GPU Nuclear Corporation
One Upper Pond Road
Parsippany, New Jersey 07054
201-316-7000
TELEX 136-482
Writer's Direct Dial Number:

February 26, 1988
C320-88-0270

SUBJECT: Information Requested by A.W. Dromerick's Letter
Dated December 16, 1987 re: Oyster Creek Seismic
Floor Response Spectra Methodology

FIGURE 1: SOIL SEISMIC WAVE VELOCITY PROFILE AT OYSTER CREEK PLANT

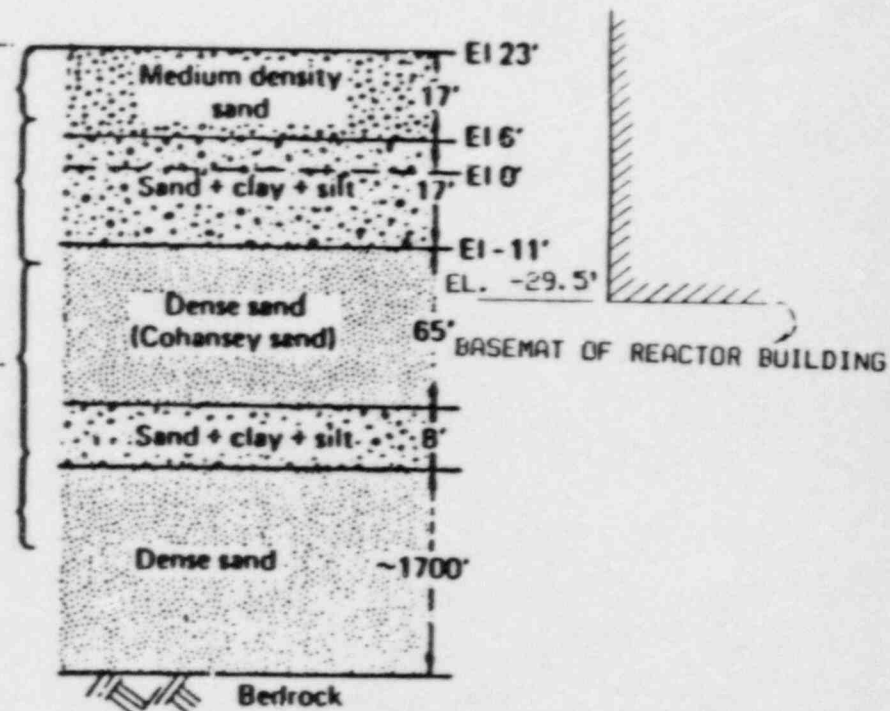
Shear (S) and compression (P) wave velocities were measured in the site area. These are presented in Figure 1. The S- and P-wave velocities are given for four layers — a 15-ft top layer overlying 25-ft, 65-ft, and 35-ft layers. Shear wave velocities increase with depth from 600 ft/sec for the top layer to 1,400 ft/sec for the fourth layer. Compression wave velocities are also measured for these layers. Poisson's ratio for each of the layers is derived from its shear and compression wave velocities. The water table varies between elevation +3 ft 6 in. to +10 ft, as monitored in the well network at the site since 1984.

FIGURE 3: SOIL PROPERTY PROFILE USED FOR SSI ANALYSES OF REACTOR BUILDING

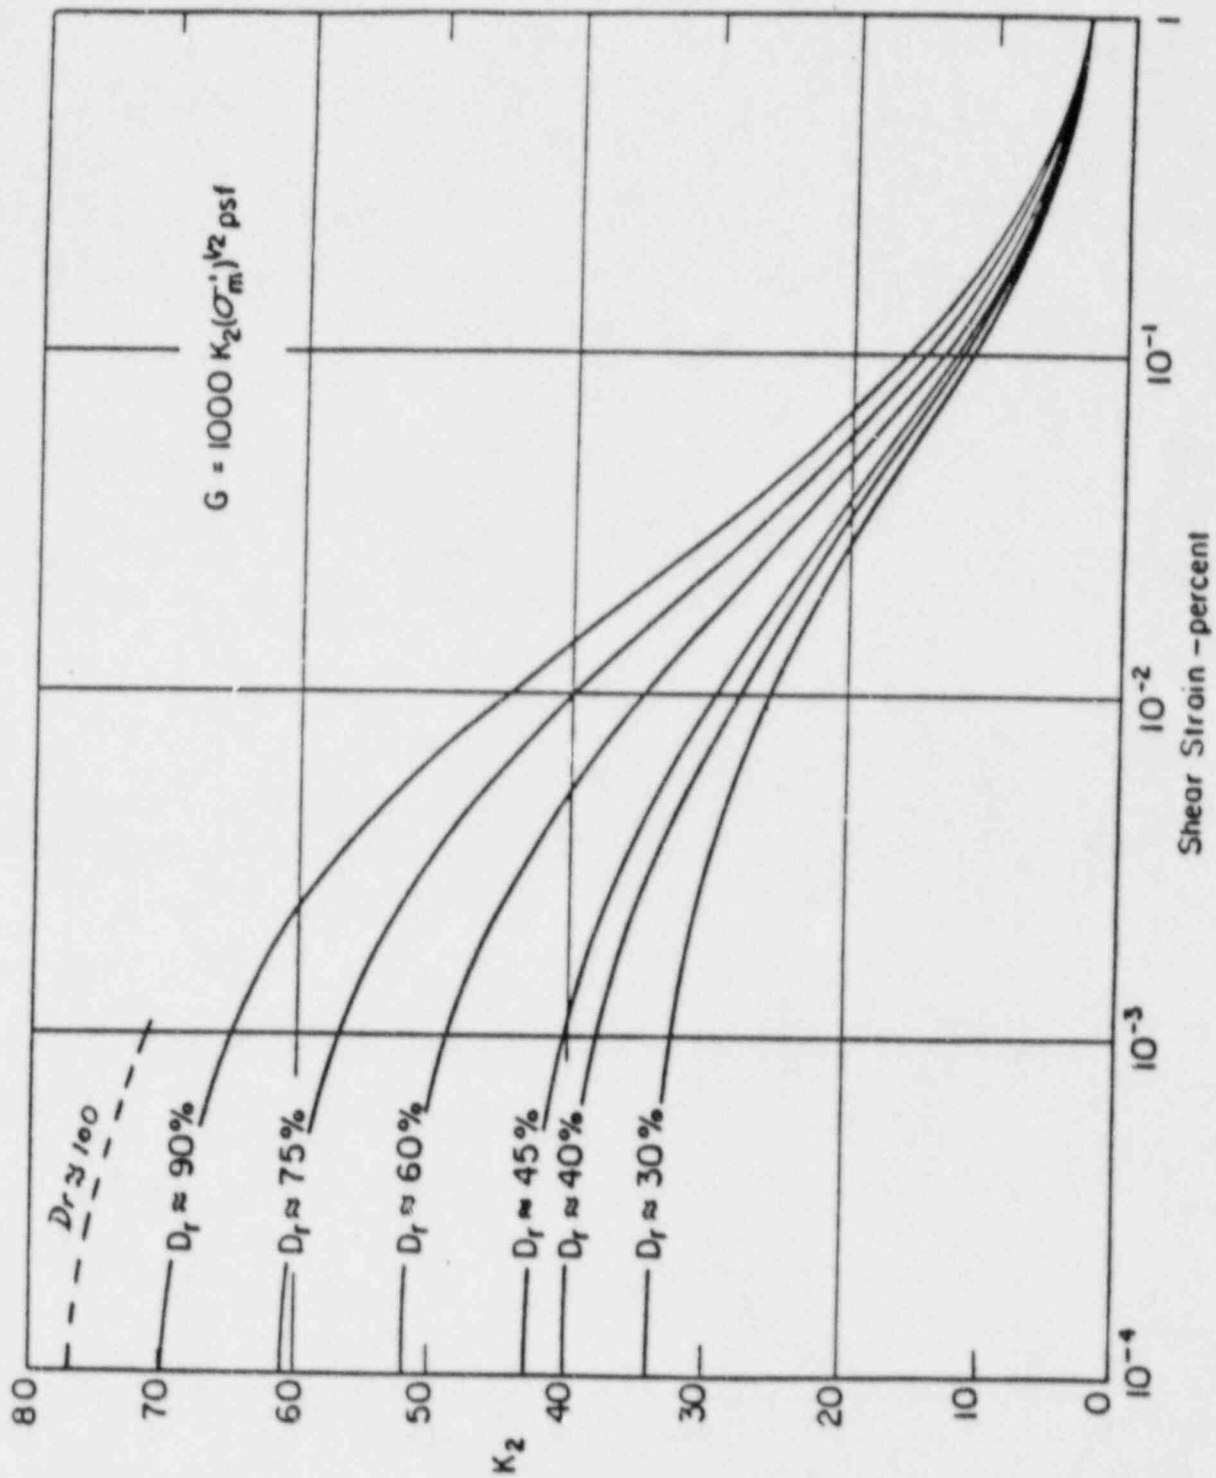
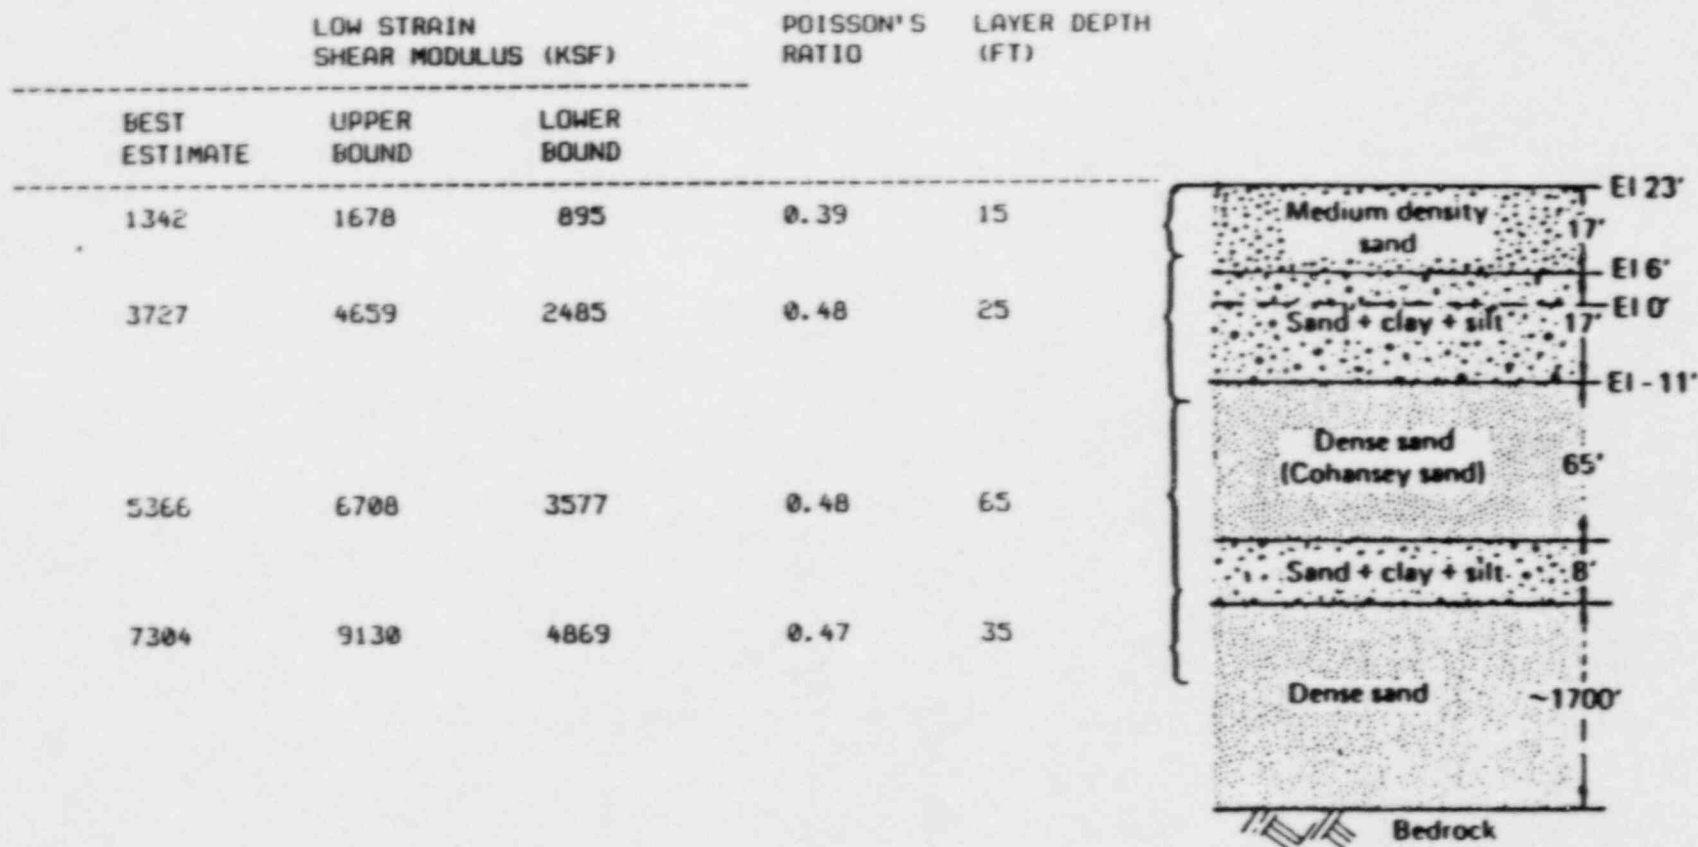
Figure 3 presents the best estimate, upper bound, and lower bound soil profiles used in Oyster Creek reactor building SSI analyses.

The best estimate, upper bound, and lower bound low-strain shear moduli for the Oyster Creek site are shown in Figure 3. The best estimate low-strain shear moduli are calculated from the shear wave velocities measured in the Oyster Creek site area. The upper bound and lower bound moduli are 1.25 and 0.67 times the best estimate values. Three SSI analyses were conducted with SuperFLUSH for the three low-strain soil profiles, and the soil layer properties (shear modulus and damping) were iterated to correspond to the shear strain state in the soil as per Figures 1 and 2. The floor response spectra, computed from these three SSI analyses, were enveloped to obtain the final spectra for the Oyster Creek project.

Figure 4. Effect of Strain-Dependent Soil Properties on Reduction of Motion at Basemat Level (El. -29'-6"), Oyster Creek Reactor Building

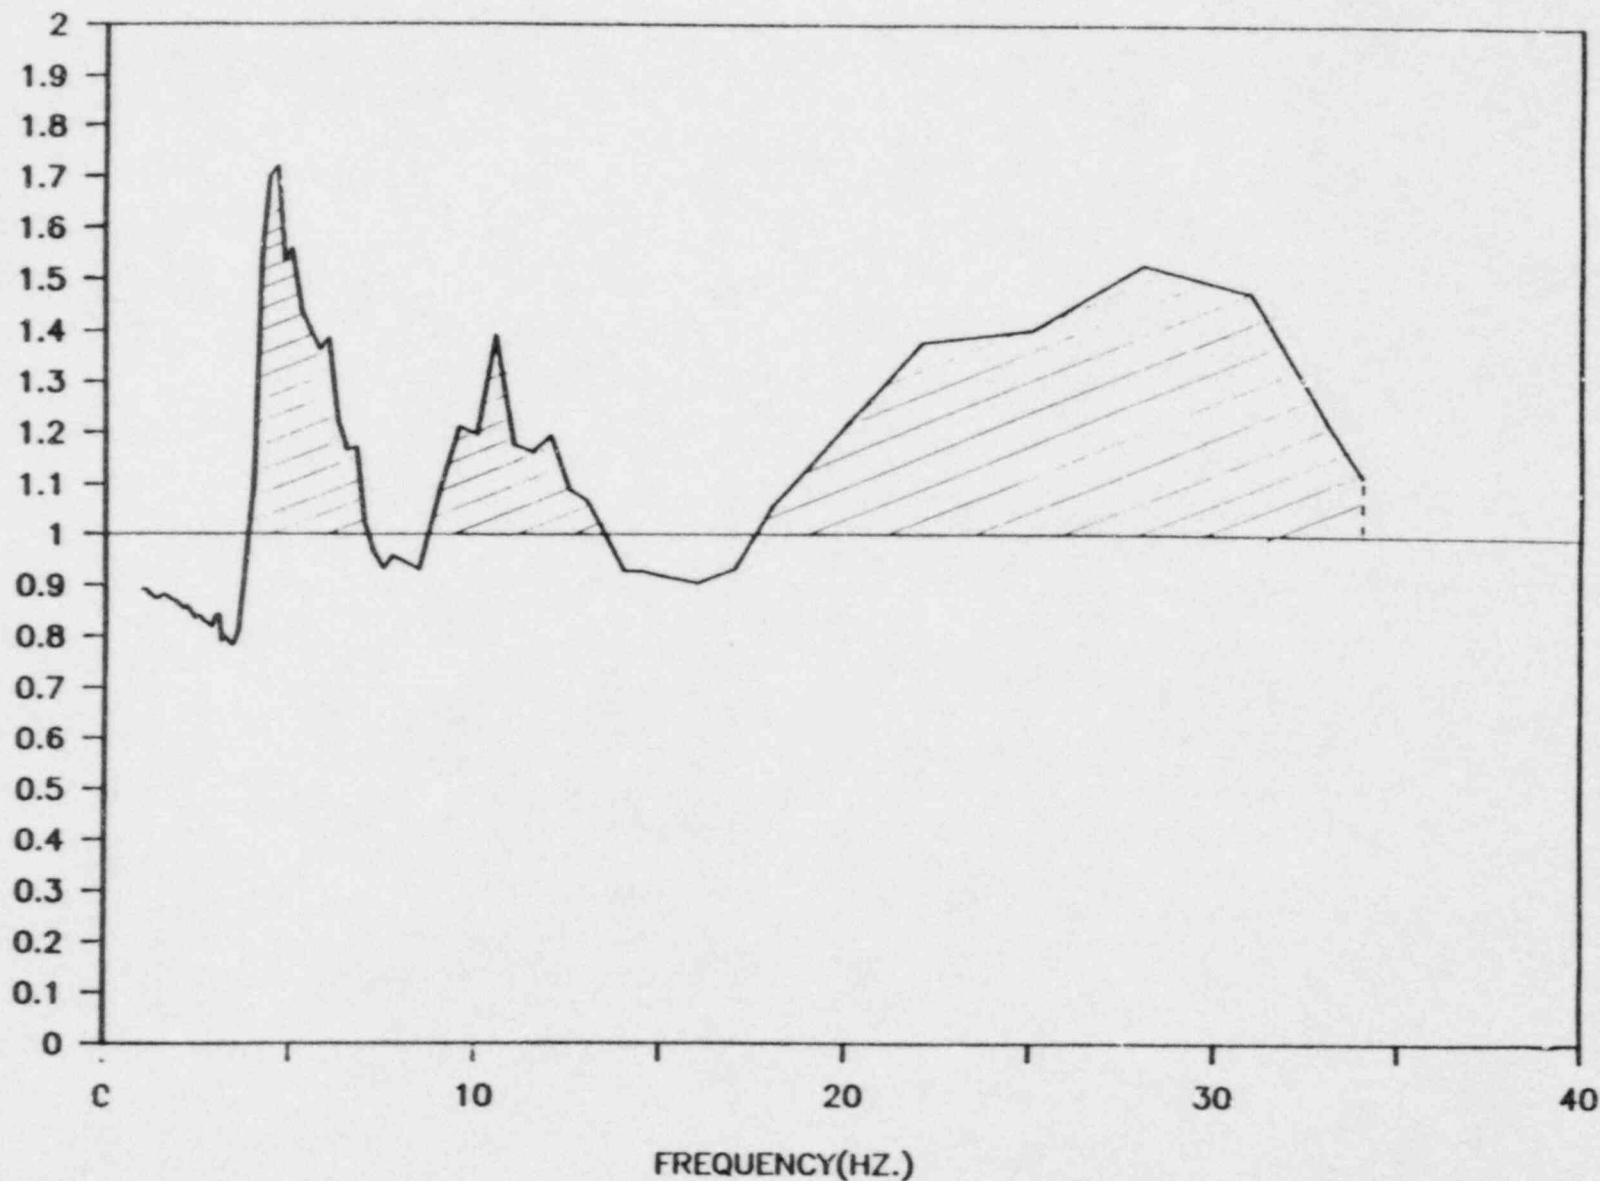
The response spectrum for the deconvolved motion at el. -29 ft 6 in. for the above-mentioned strain-independent best estimate soil profile was computed. This was compared with the response spectra at the same level, computed for the project using the envelope of spectra from strain-dependent best estimate, upper bound, and lower bound soil profiles. The ratio of the spectral amplitudes of the project spectrum to the strain-independent response spectrum is plotted as a function of frequency in Figure 4. A ratio value of less than 1.0 implies that consideration of strain-dependent soil properties and enveloping results from the three soil cases give lower response spectral amplitudes at that frequency than a strain-independent analysis with best estimate soil case would yield. As shown in Figure 4 (shaded area), in most frequency ranges, the spectral amplitudes are increased (by as much as 50% to 70%) due to consideration of strain-dependent soil properties and enveloping the three soil profiles. In the rest of the frequency ranges, there is a reduction of less than 10%, except in a very narrow range, where it goes up to about 20% reduction in a frequency range of 2.5 hz to 4 hz.

It is concluded from the above study that the consideration of strain-dependent soil properties in Oyster Creek SSI analyses does not lead to significant reduction in basemat motion. In most frequency ranges, spectral amplitudes are increased due to the strain-dependent soil cases when compared to strain-independent, best-estimate soil case. In other frequency ranges, the differences are less than 10% when compared to responses obtained assuming very conservative soil strains ($10^{-3}\%$) during seismic motion and only 7% reduction in soil shear modulus and 1.6% damping in soil. Even for the extreme case of no reduction in soil shear modulus and 1% soil damping, the reductions are mostly less than 10% in all frequency ranges of interest.

Figure 5. Effect of Strain-Dependent Soil Properties on Reduction of Motion at Basemat Level (El. -29'-6"), Oyster Creek Reactor Building

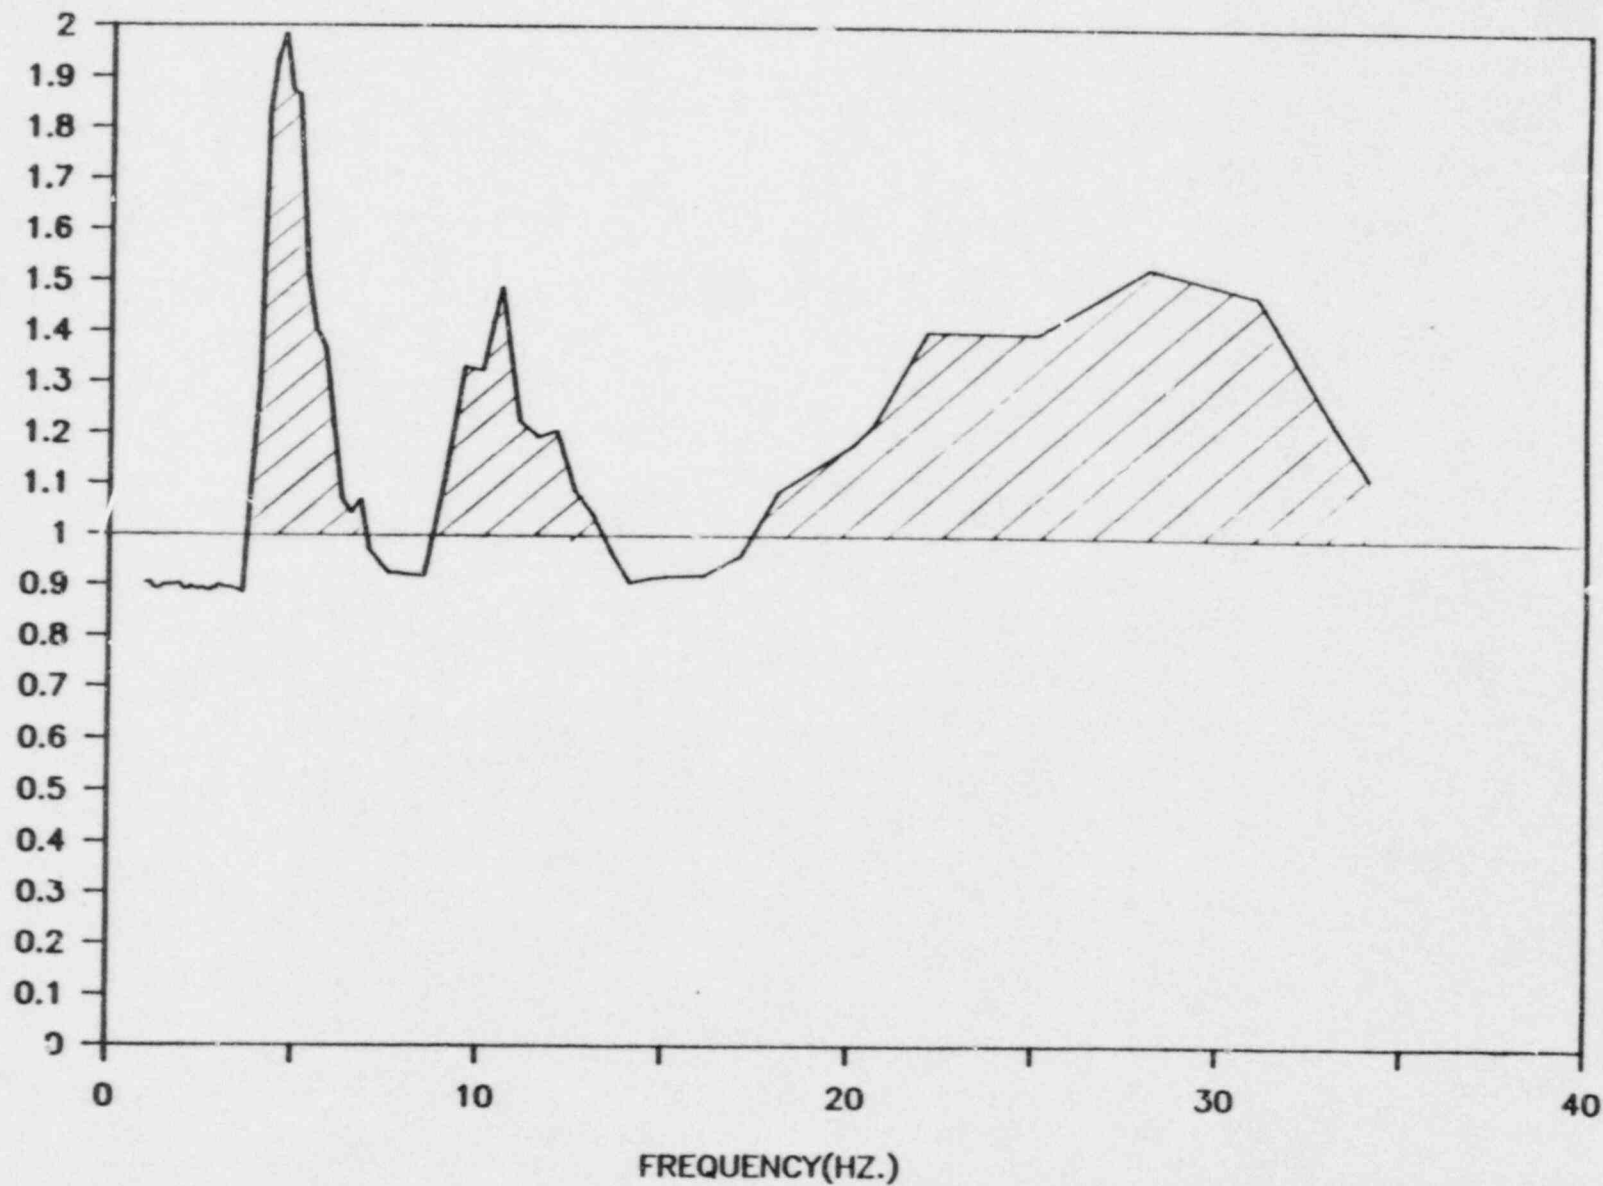
To further investigate the effects of soil strain-dependent properties on soil motion, we considered a case where soil shear strain is assumed to be consistent with Seed and Idriss curves at a strain of $10^{-3}\%$. This is a very conservative estimate of the possible soil strain during an SSE event. The best estimate soil modulus at $10^{-3}\%$ strain is 93.4% of the low-strain ($10^{-4}\%$) value. Corresponding damping is 1.6%. Deconvolved motion at this soil condition was computed, and spectral ratios similar to Figure 4 are plotted in Figure 5. As shown in Figure 5 (shaded area), in most frequency ranges, the spectral amplitudes are increased due to consideration of strain-dependent soil properties. In the rest of the frequency ranges, there is less than 10% reduction in spectral amplitudes.
